Harman International Industries, Inc.

Request of Class II Permissive Change

FCC ID: APIJBLXTREME3G

This is to request a Class II Permissive Change for FCC ID: APIJBLXTREME3G originally granted on 08/19/2020, due to battery cell and AC adapter added.

Adapter:

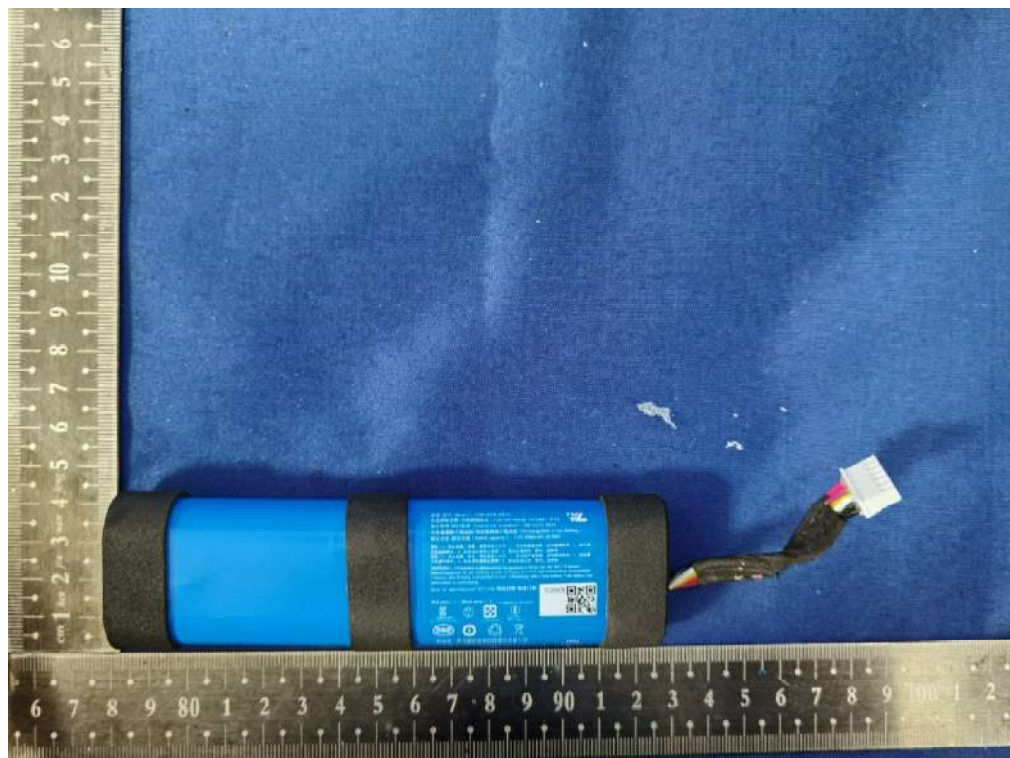
| Adapter | | Manufacture | Model | Description |
| | Original | Group Intellect Power Technology Limited | GHWM-PD60W-WC | Input: 100-240V ~ 50/60 Hz 1.5A Output: 5.0V === 3.0A, 9.0V ===3.0A, 12.0V ---3.0A, 15.0V ---3.0A, 20.0V ===3.0A |
| | New | Shenzhen JingQuanHua & Everrise Intelligent Electric Co., Ltd | NSA60EU-200 3000 | Input: 100-240V ~ 50/60 Hz 1.5A Output: 5.0V === 3.0A, 9.0V ===3.0A, 12.0V ---3.0A, 15.0V ---3.0A, 20.0V ===3.0A |
